August 20, 2018
BOARD OF COUNTY COMMISSIONERS
ORANGE COUNTY, FLORIDA
Addendum No. 1, IFB Y18-789-EB
BARBER PARK PLAYGROUND IMPROVEMENTS

Bid Opening Date: August 30, 2018

CONSTRUCTION PLANS FOR ORANGE COUNTY PARKS & RECREATION BARBER PARK PLAYGROUND IMPROVEMENTS DISTRICT NUMBER 3 ORANGE COUNTY, FLORIDA

DEMOLITION PLAN - PLAYGROUND

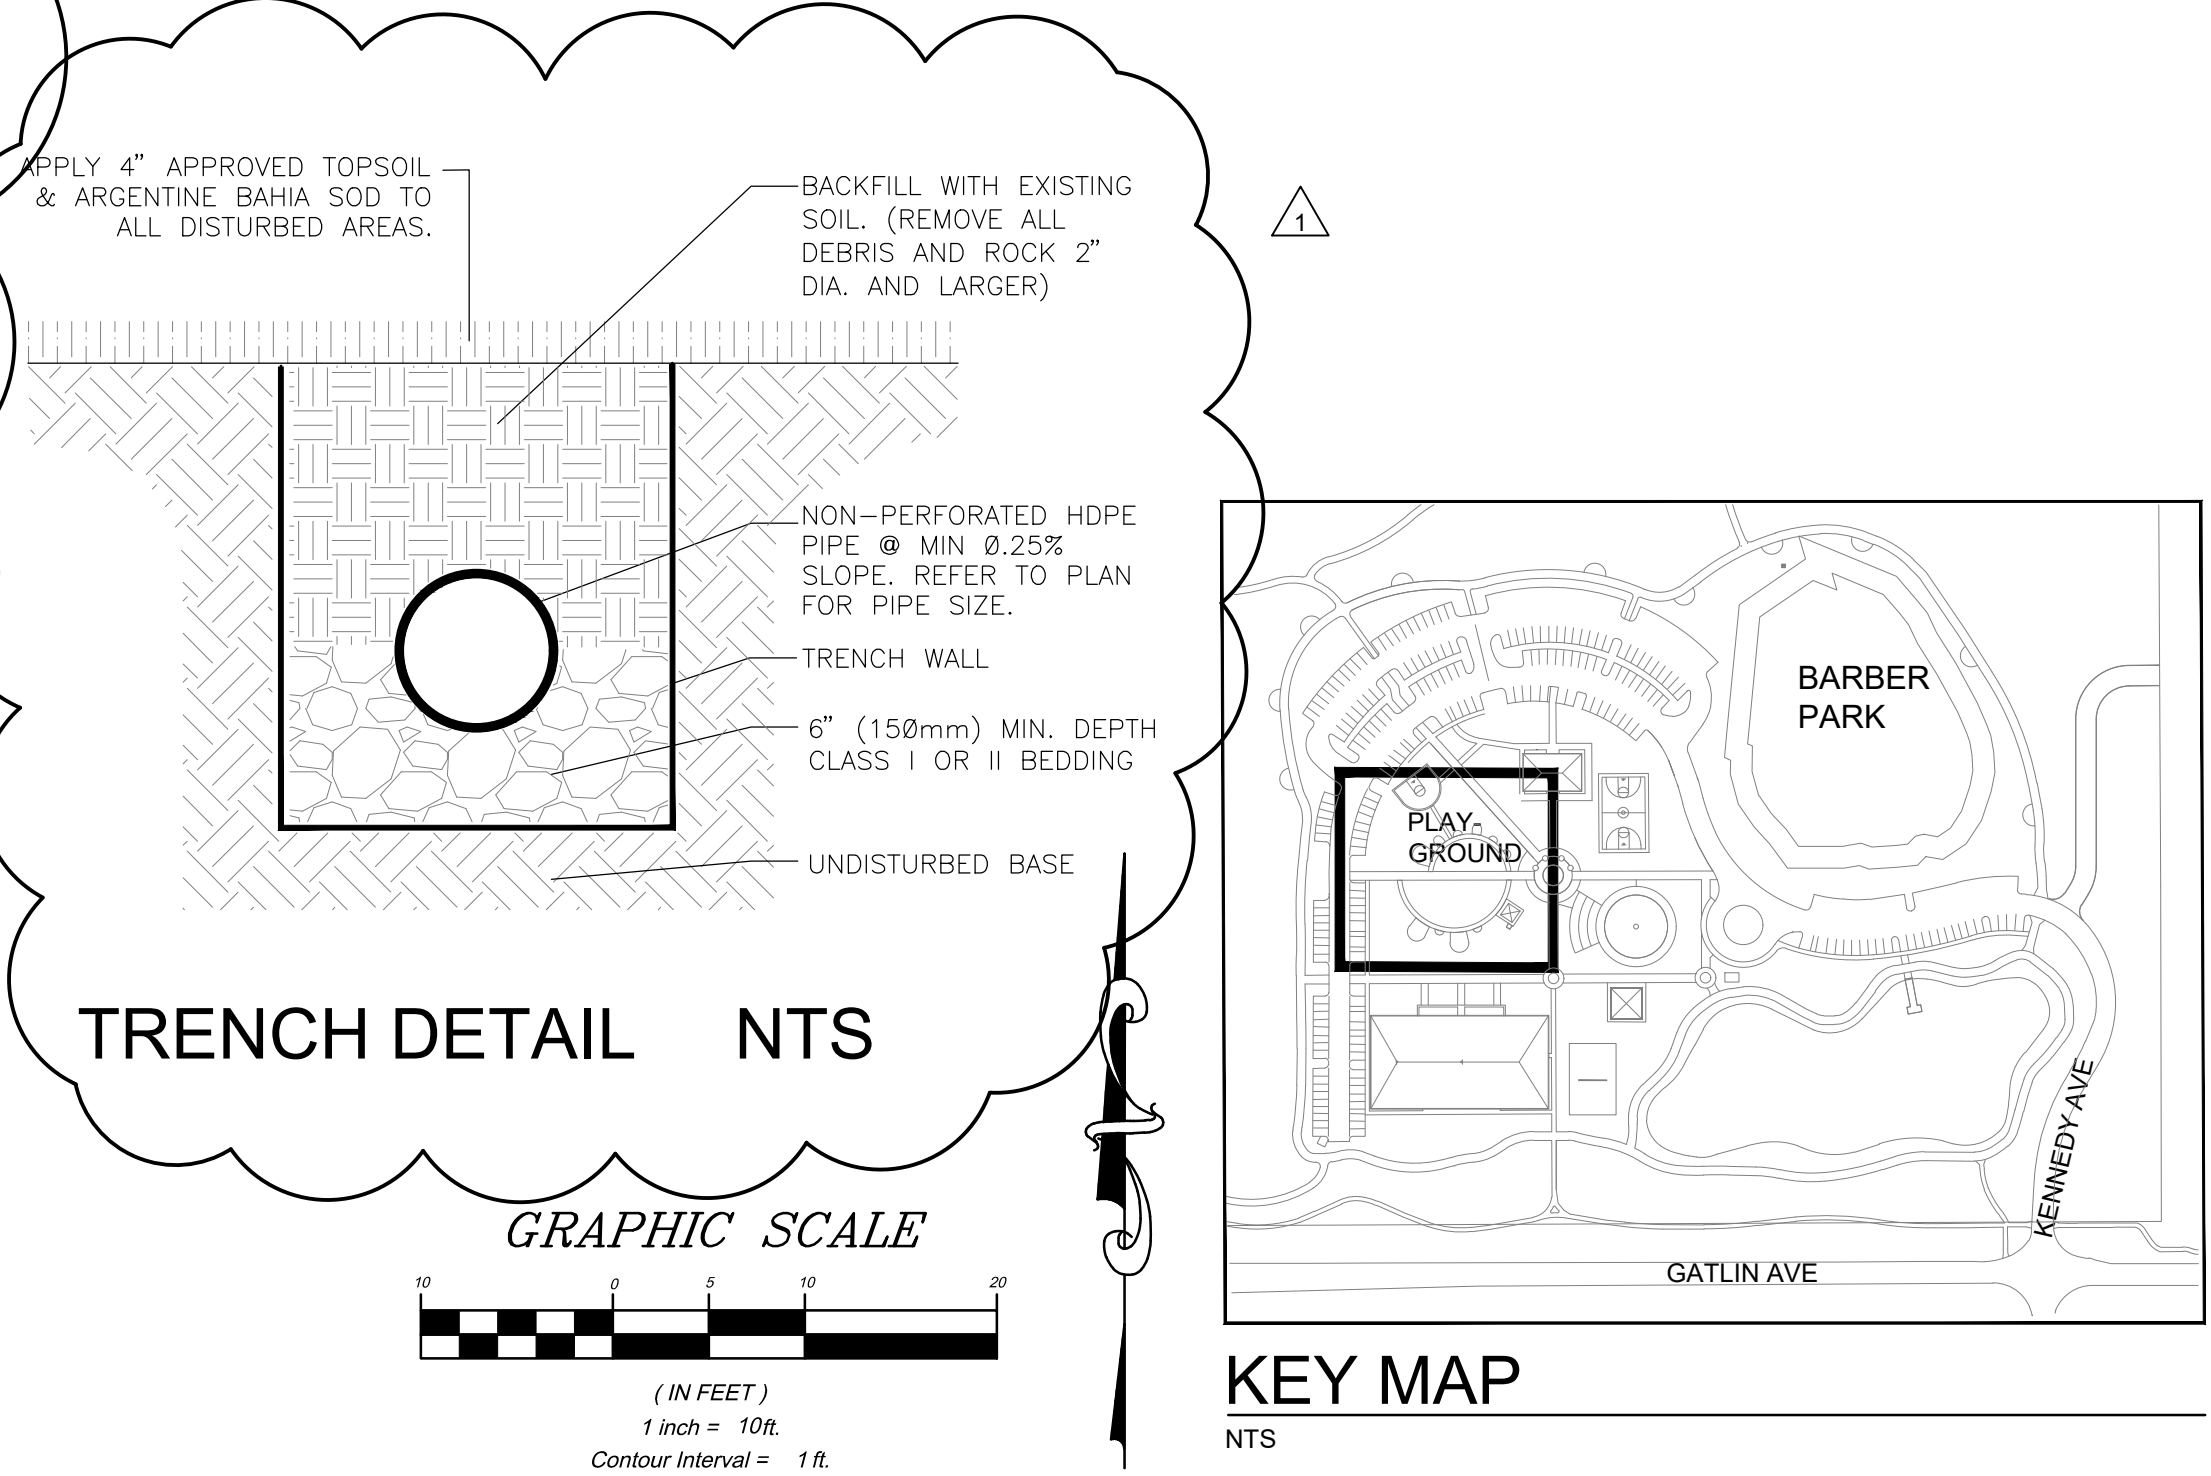
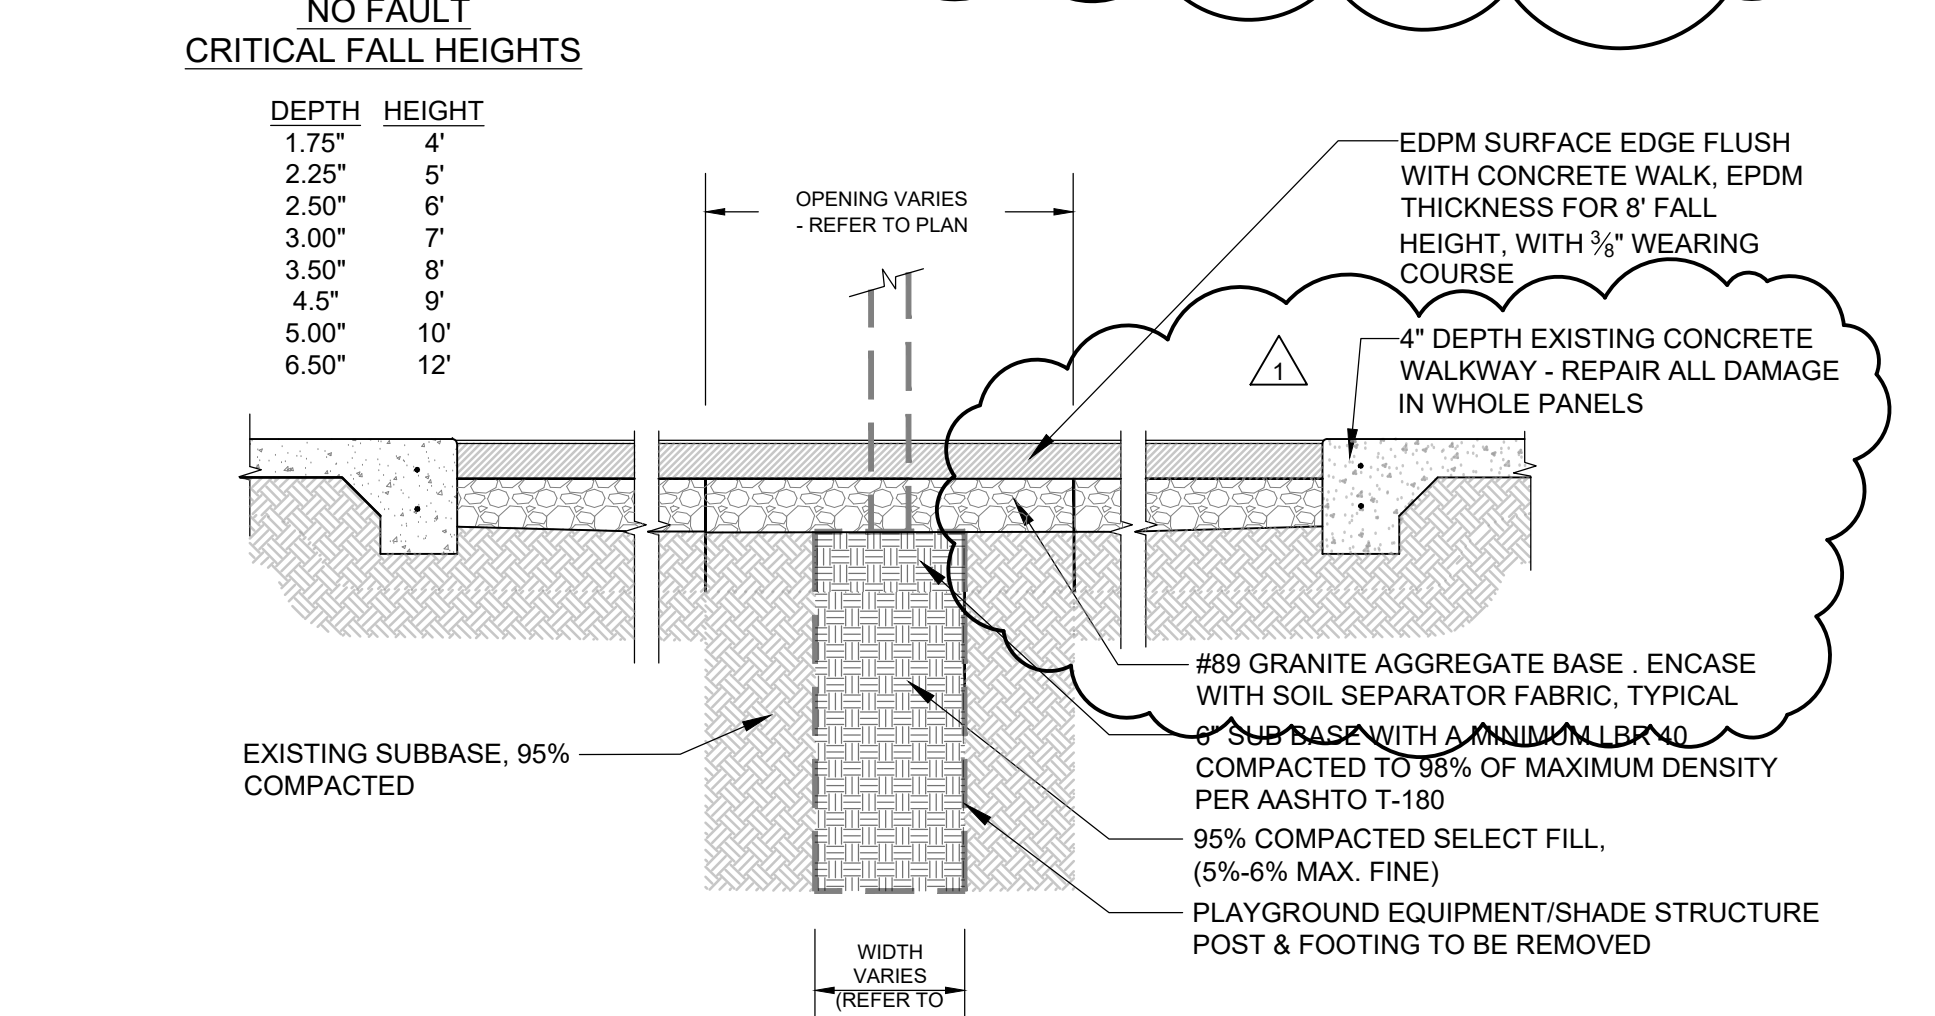
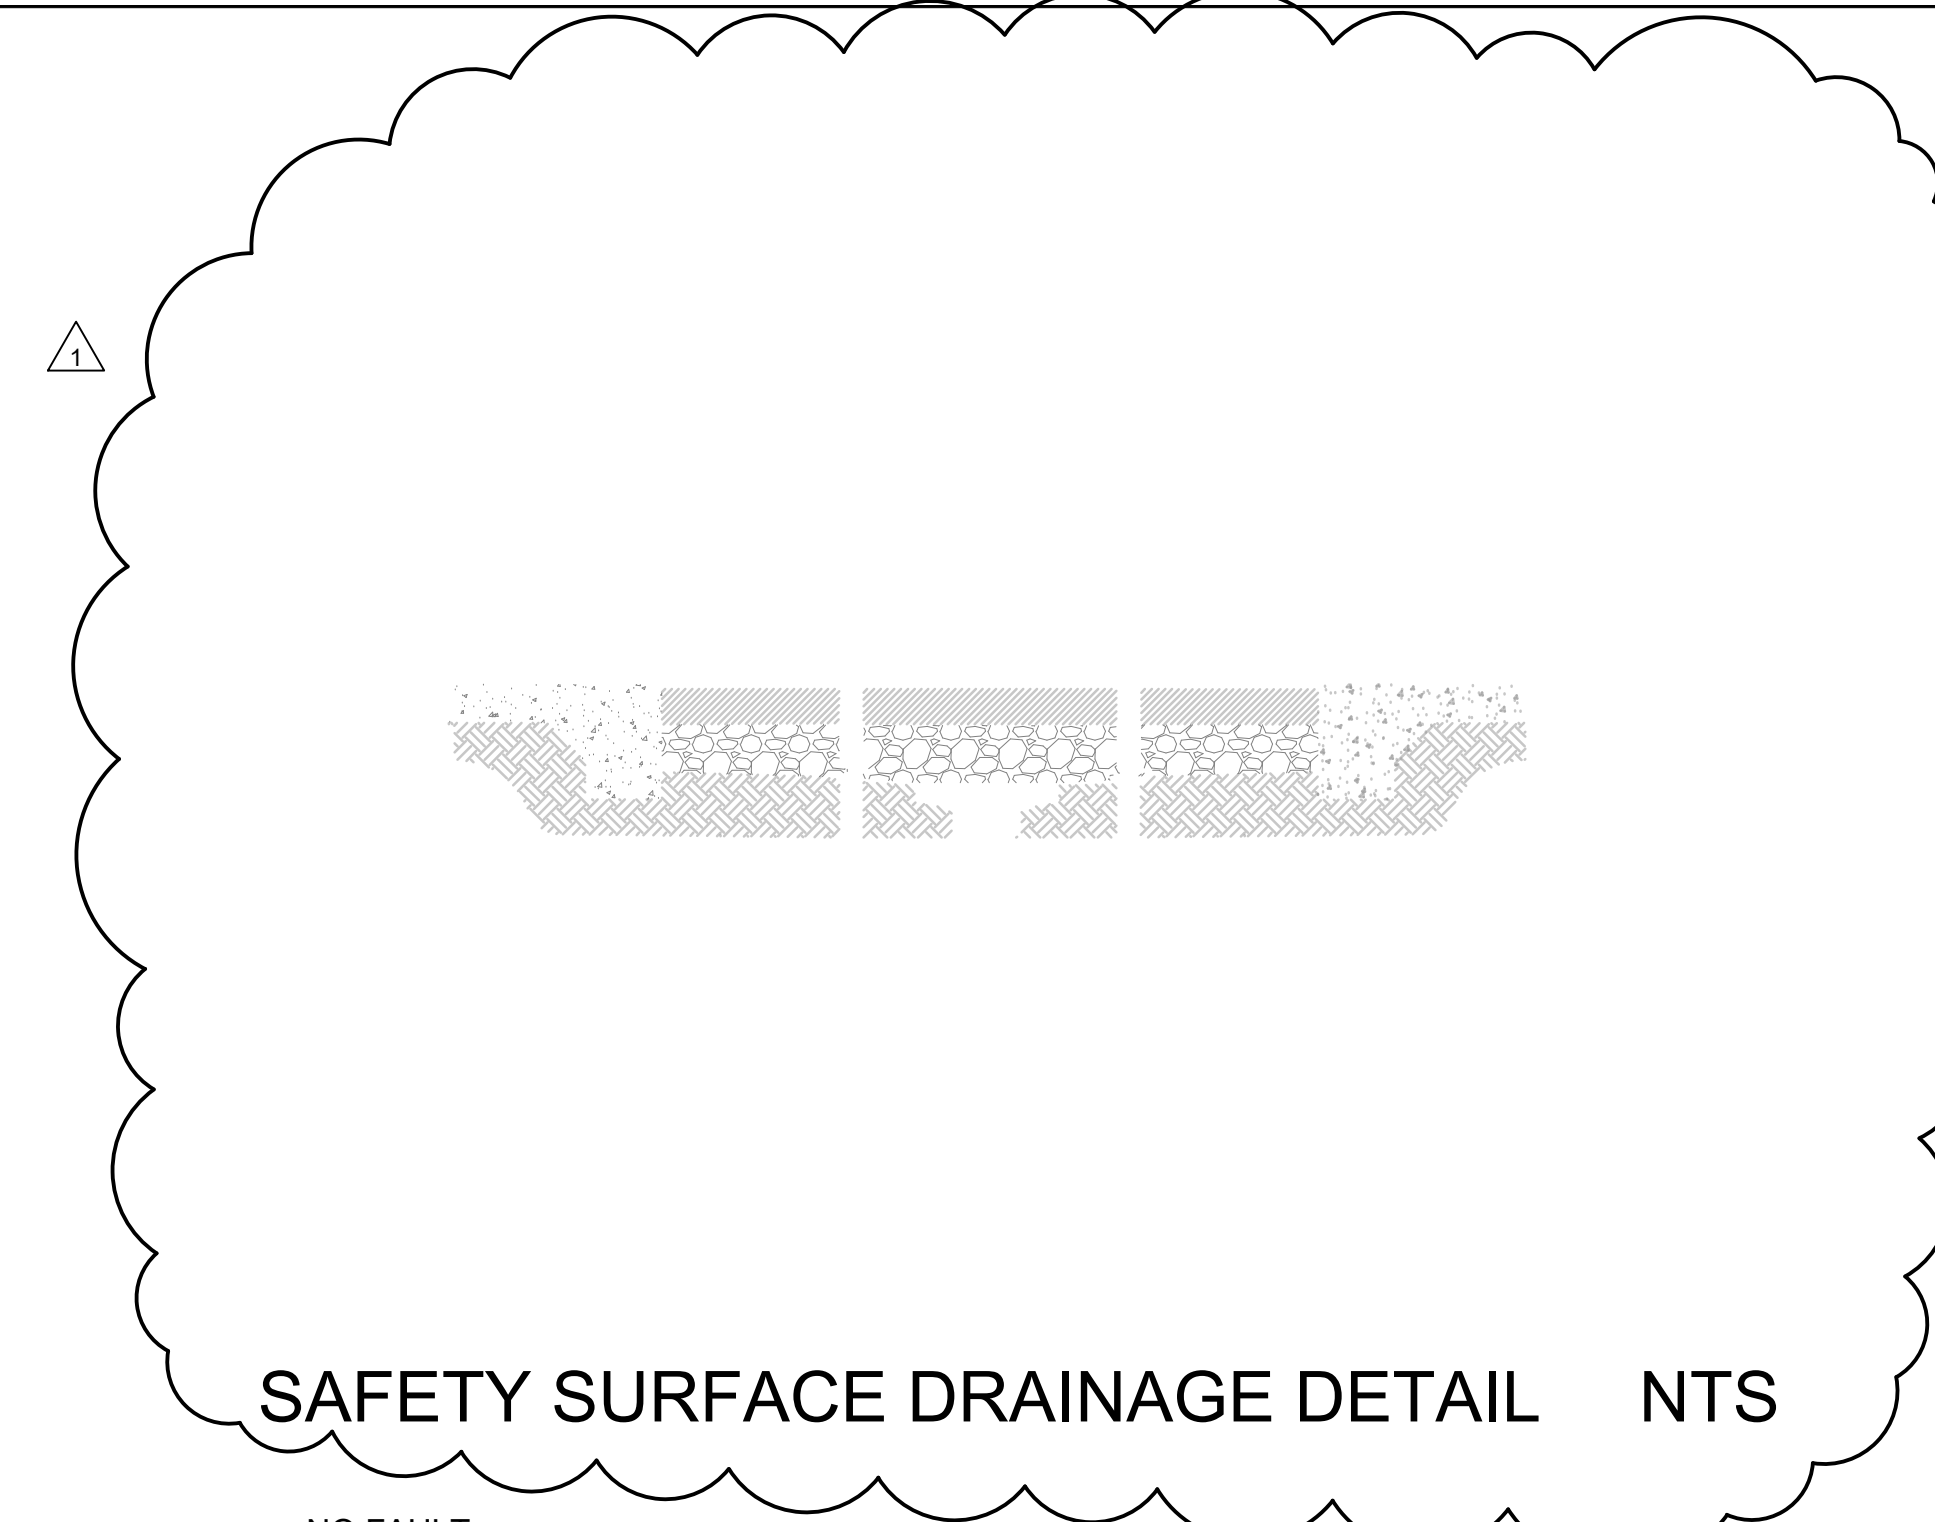
- Title block revision for Addendum #1 – no other changes.
- Sheet C.4 Demolition Plan – Playground dated 8/17/18
 - Fence removal note revised. All fencing located outside of the existing playground safety surface is to remain. All fencing located within the existing playground safety surface area is to be removed.

- All playground equipment and shade structures and all associated footings located within the existing playground safety surface area are to be removed.

- All existing playground safety surface and associated concrete base slab, drains, and pipes to be removed.
 - All repairs to existing concrete walkway to be replaced in whole panels.

- Contractor to locate and cut and cap existing drainage pipe. Contractor to clean existing drainage line prior to reconnecting to new playground drainage pipe.

- Note to bidders removed from top left corner of sheet.
 - 'Demolition Plan Keyed Notes' revised.
 - Concrete pad at north end of playground to remain.
